Report for the Grenfell Tower Inquiry

The application for Building Regulations approval (Part B Fire) in relation to the refurbishment of Grenfell Tower - extent of control, the Building Control process adopted, the referenced guidance and practices adopted

Beryl Menzies FCABE PPBEng CBuildE CABE MRICS

October 2019 (Amended April 2020)

Doors on escape routes provided with simple fastenings - without the use of a key

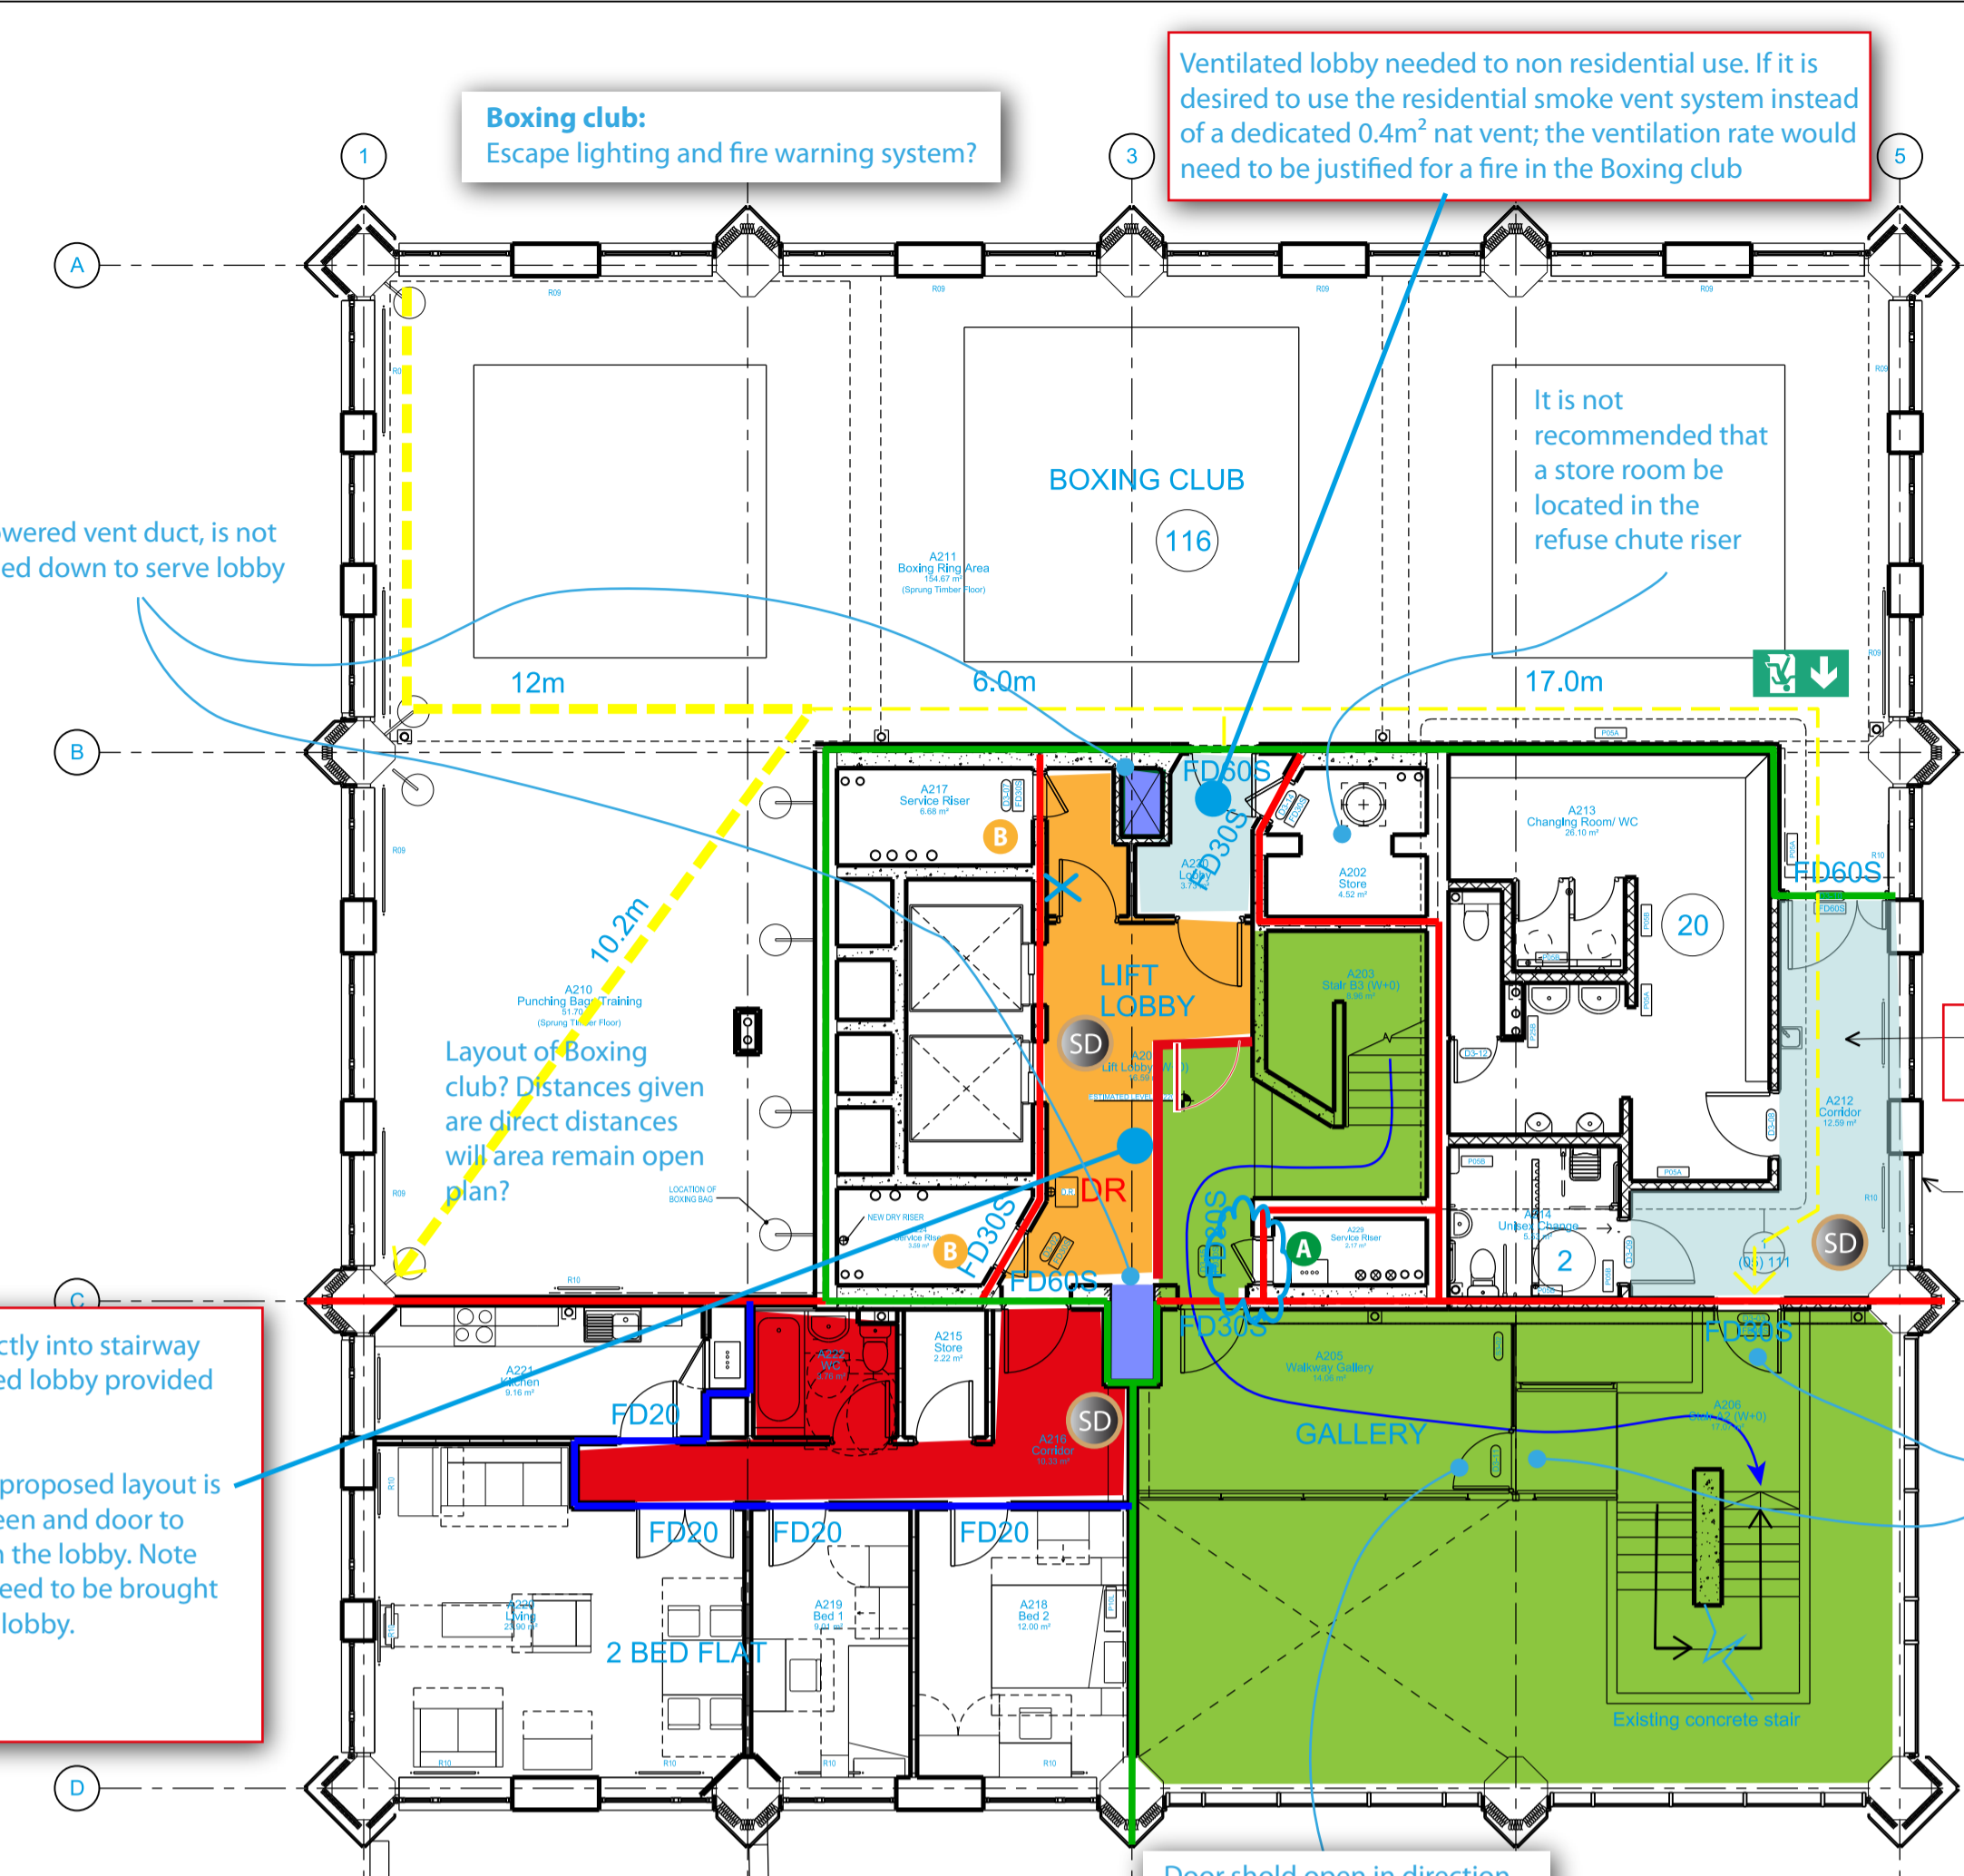
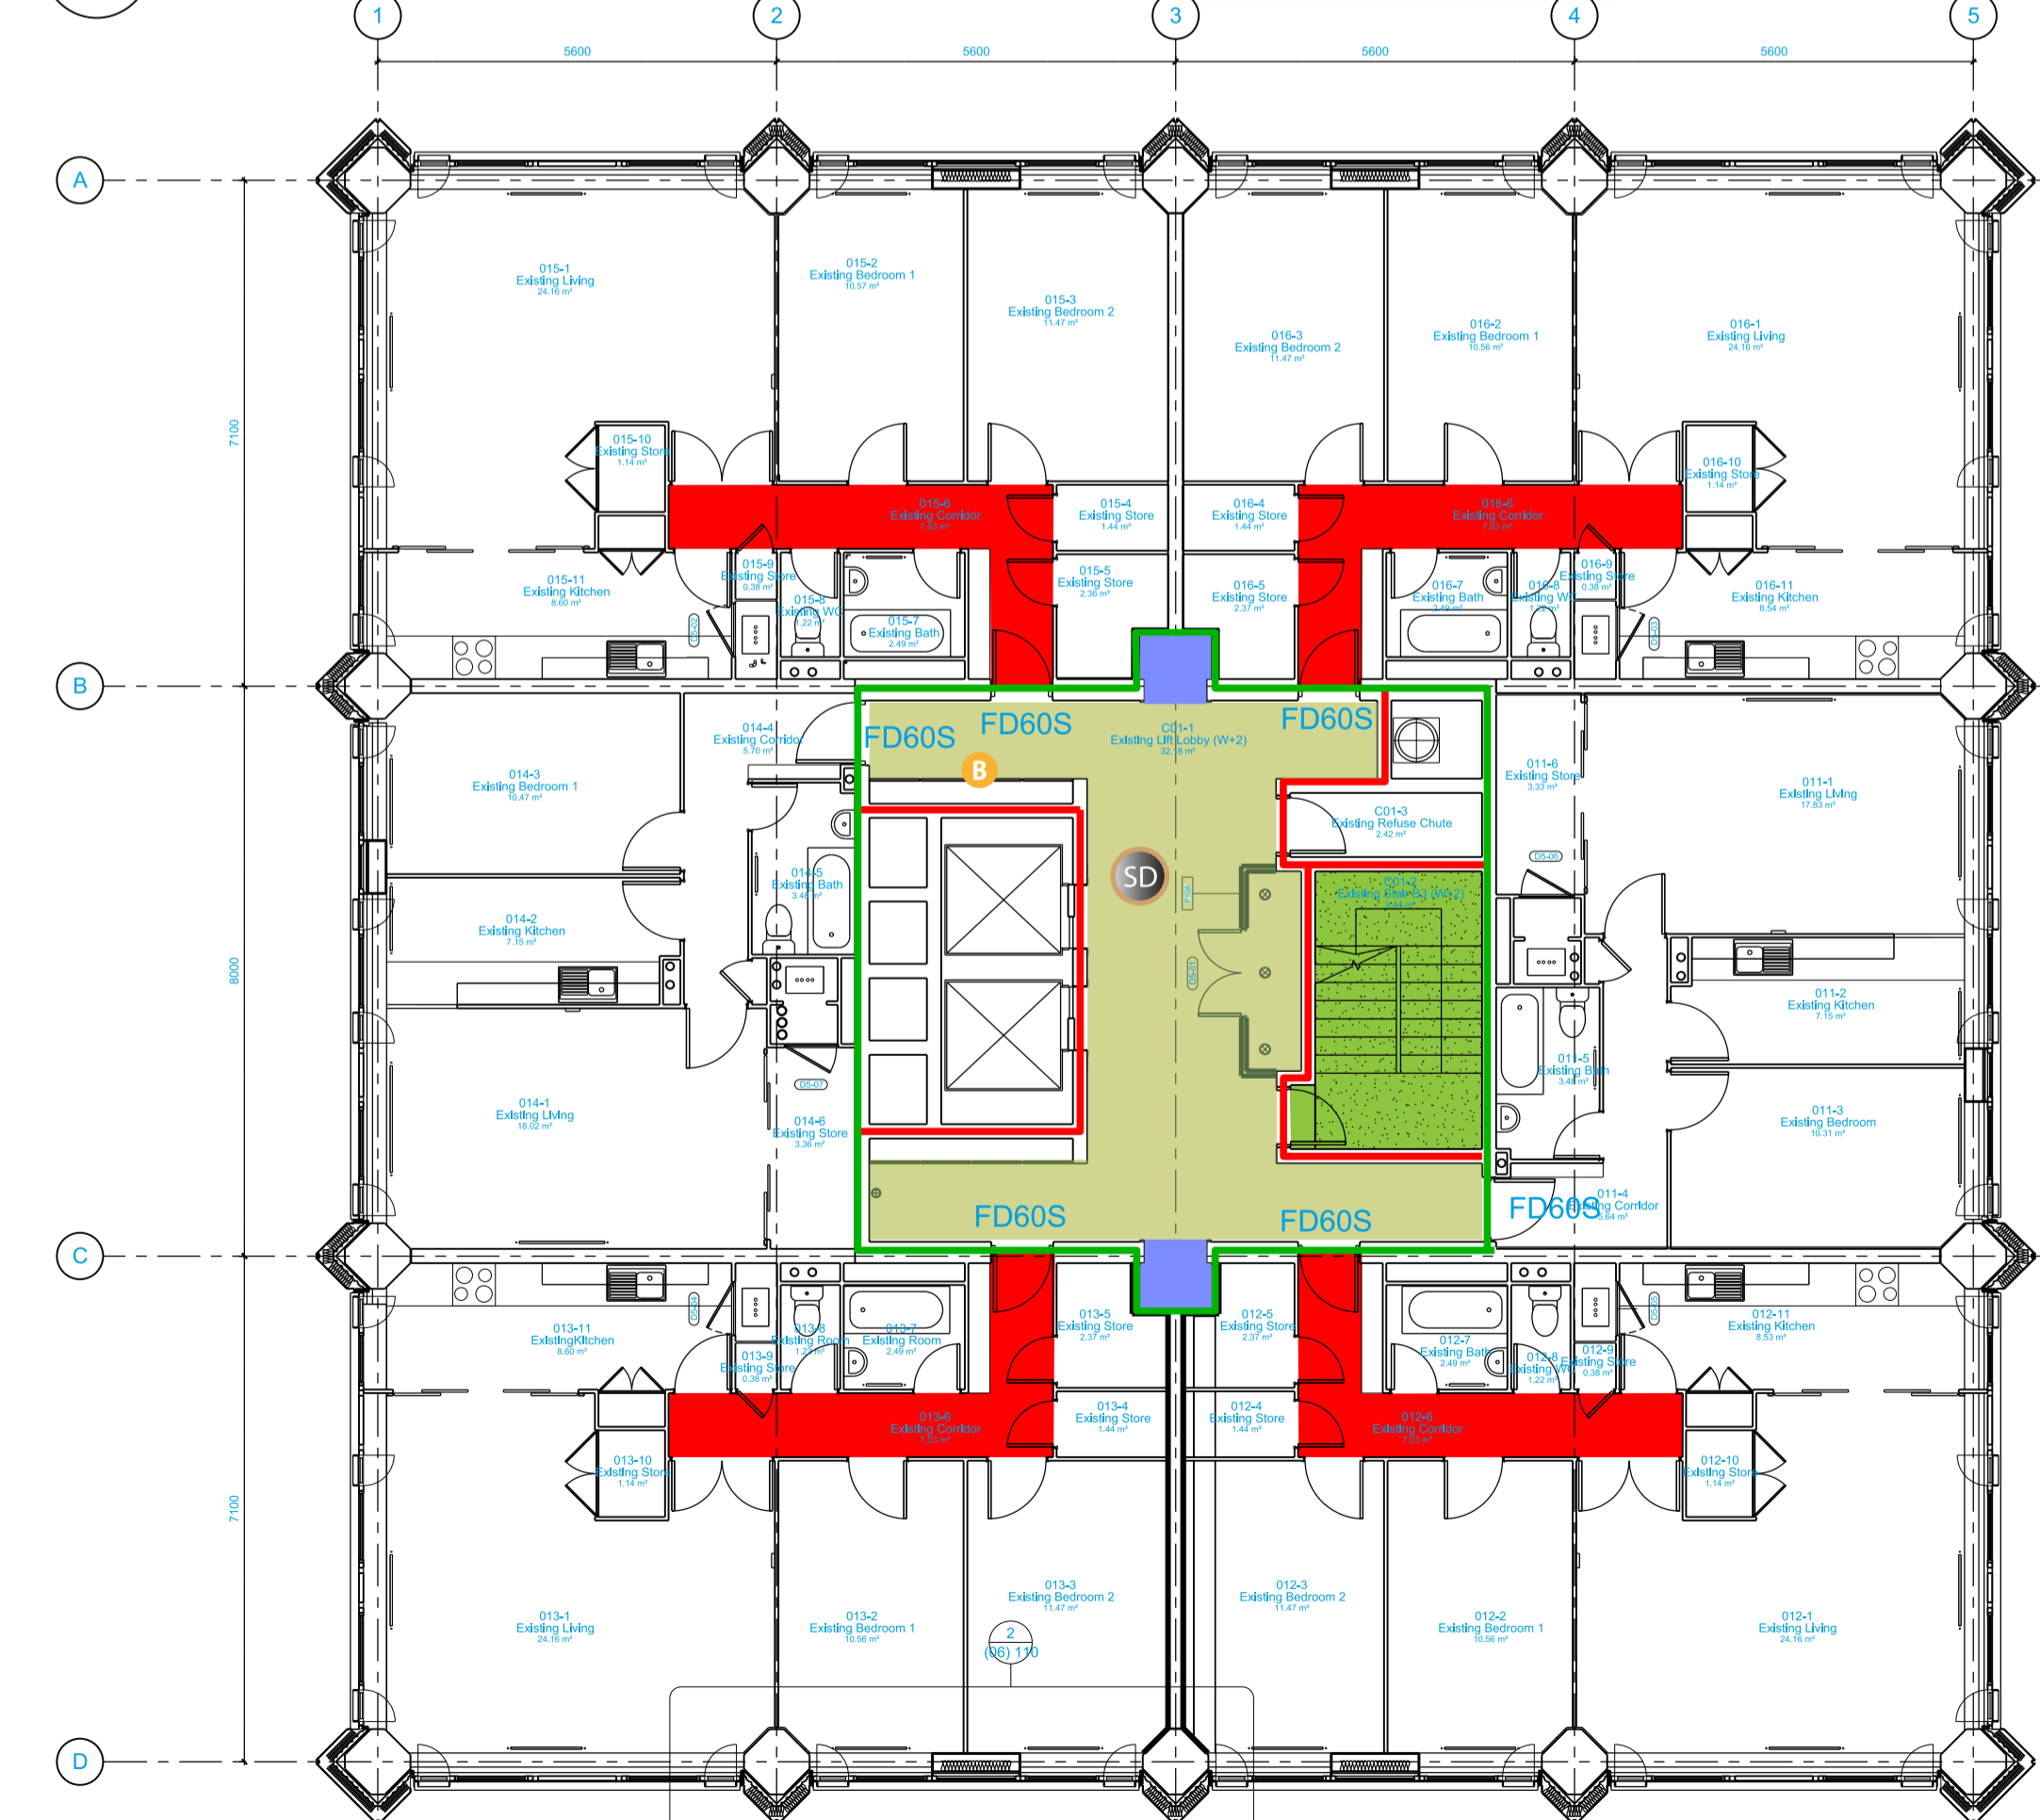
This is a room. Venting the room would not provide the same level of protection as venting a lobby thereto.

Provided that the lift lobby is vented - in this case an additional unvented (red) lobby separation to the residential escape is considered appropriate. The lobby in red should be completed with inner and outer FD30S doors.

Route of powered vent duct, is not shown carried down to serve lobby

Layout of boxing club? Distances given are direct distances with area remain open plan?

Residential flat opens directly into stairway without common ventilated lobby provided on other floors.

TR30032015 Hcw 001

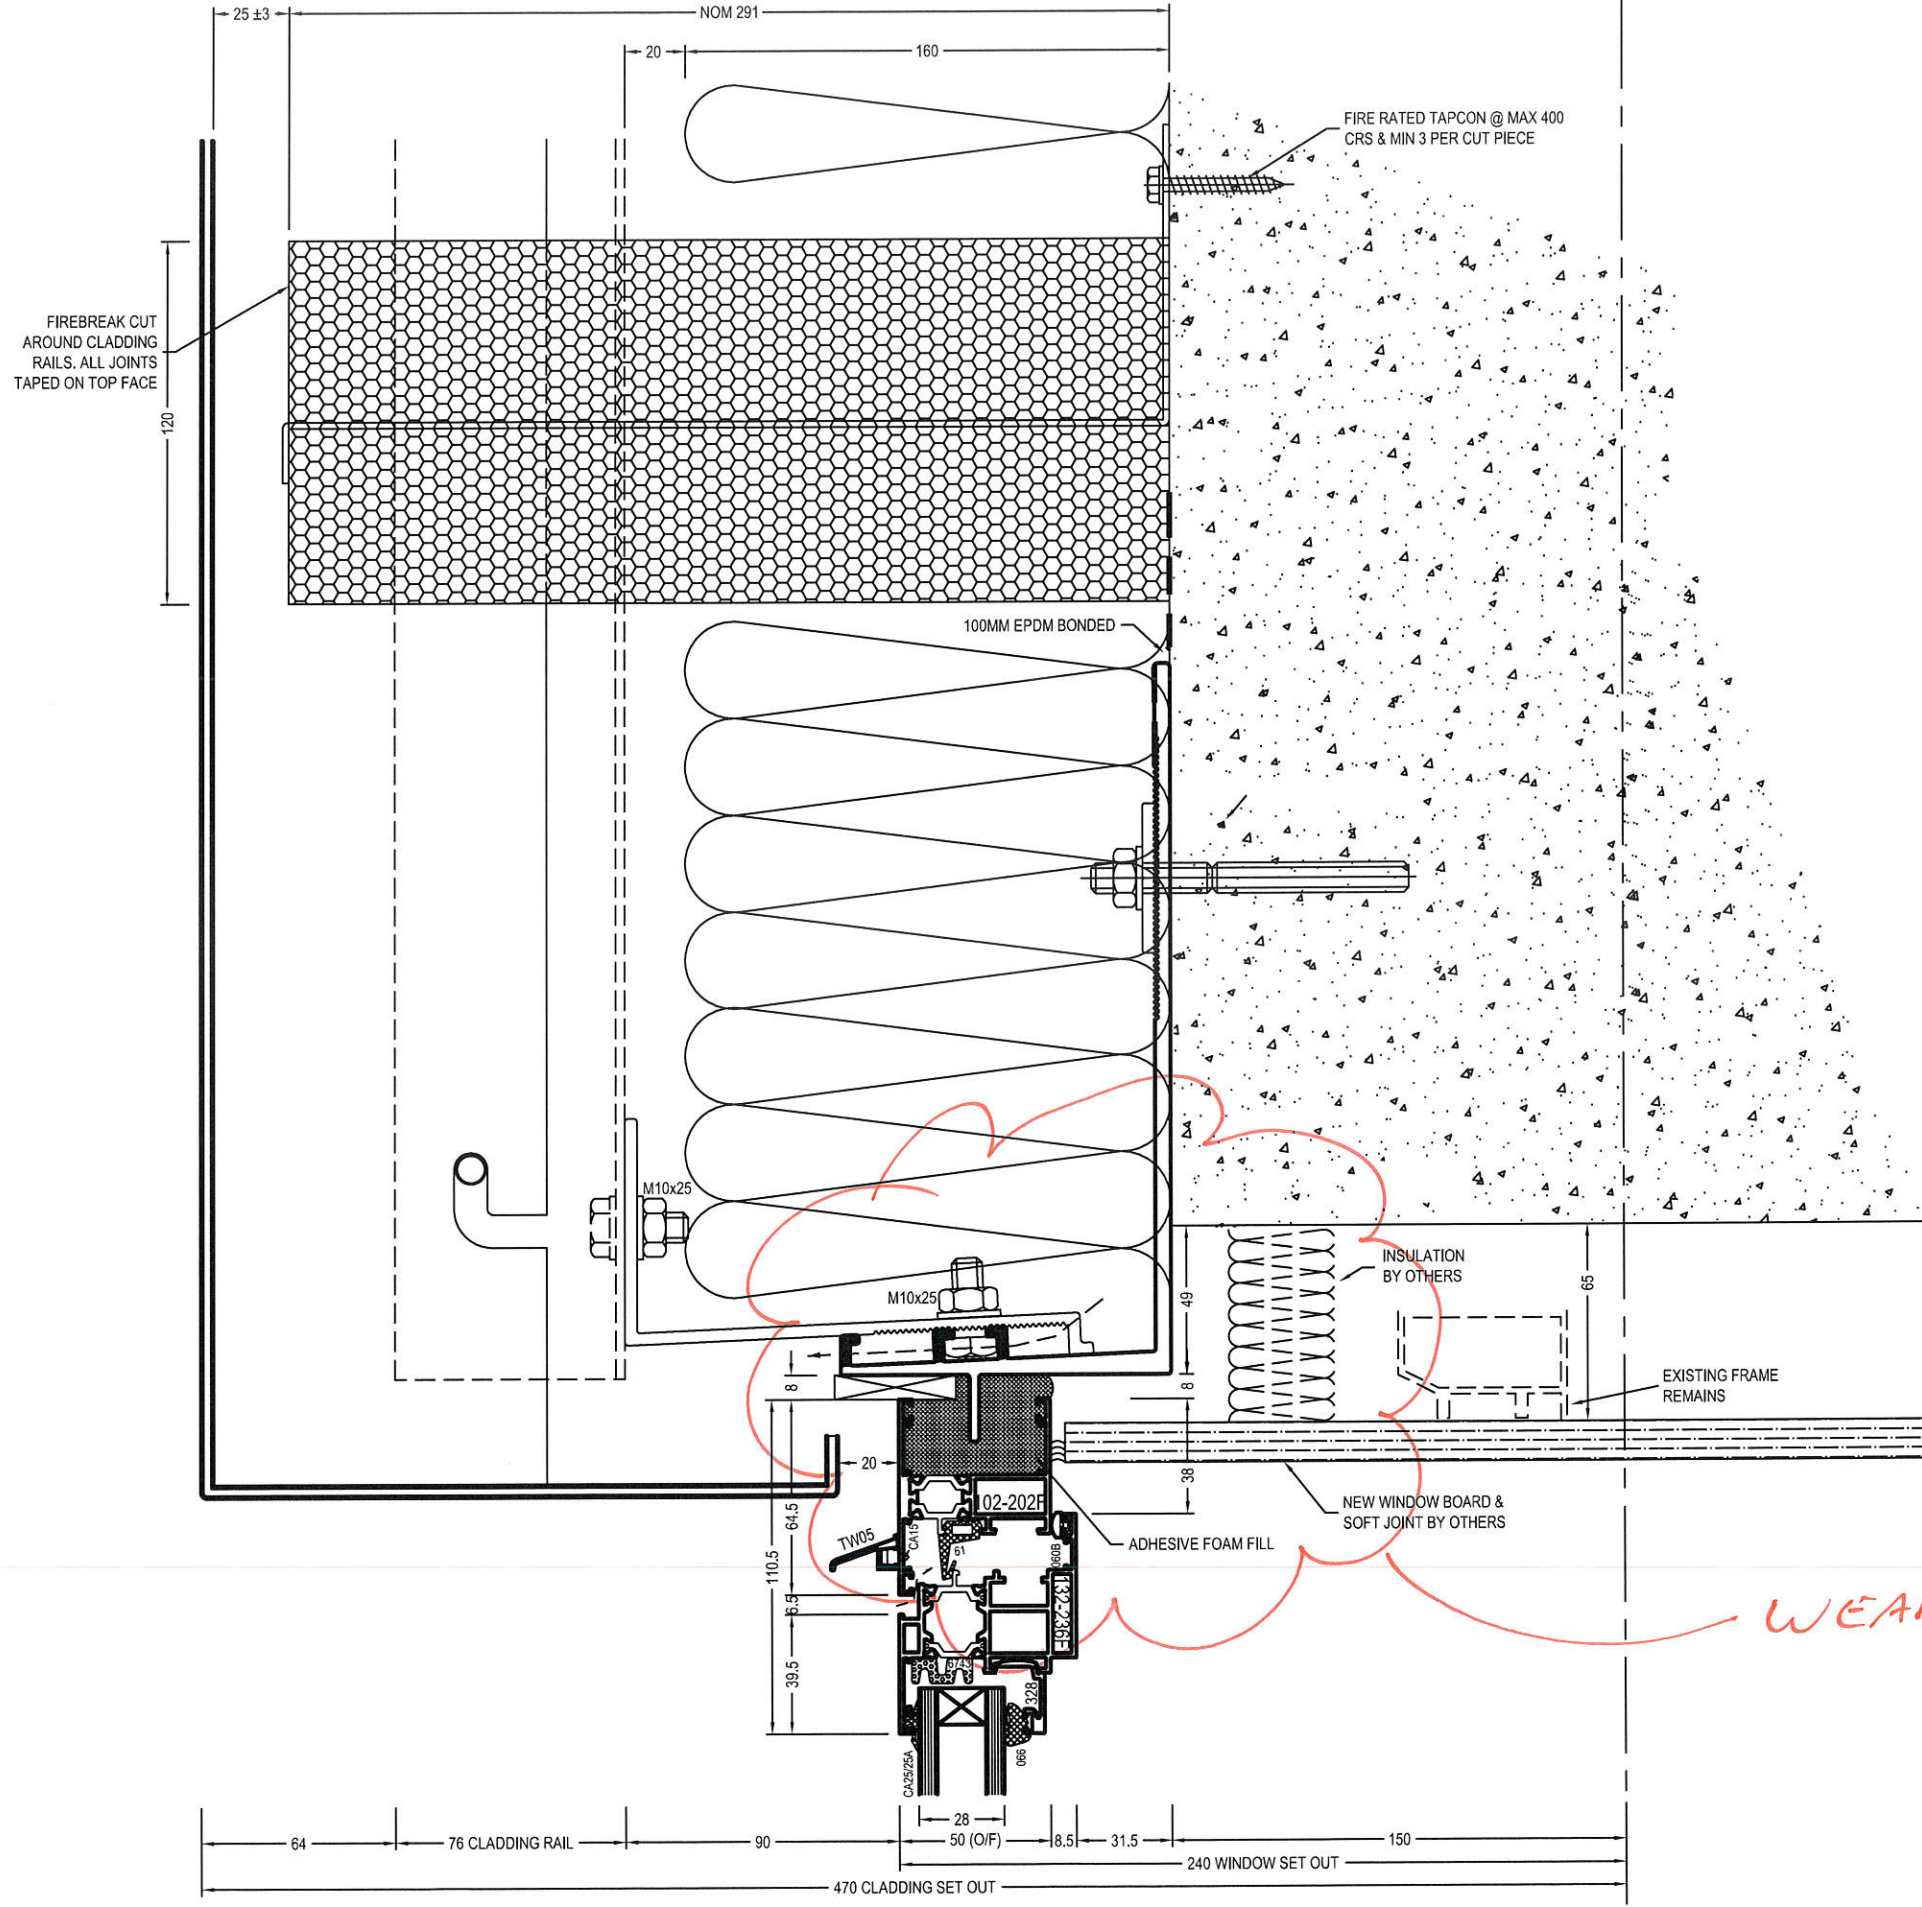
- 391) An email from Siderise dated 30 March 2015 {SIL00000024} Following their review of the Harley drawings, Siderise states "on the second page of the attachment I have highlighted the weak link in terms of fire and I think the BCO would have noticed this". The email goes on to state "The proposal requires the installation of RH25g 90/60 product in two layers one at the head of the window aligning with the compartment floor and the other at the top of the existing upstand, therefore two layers of 60 minutes protection that overall would provide if tested over 120 minutes protection at the window locations". The disclosure has not reproduced clearly but the email chain is repeated together with the attachments in {HAR00003947}. The sketches are shown below.
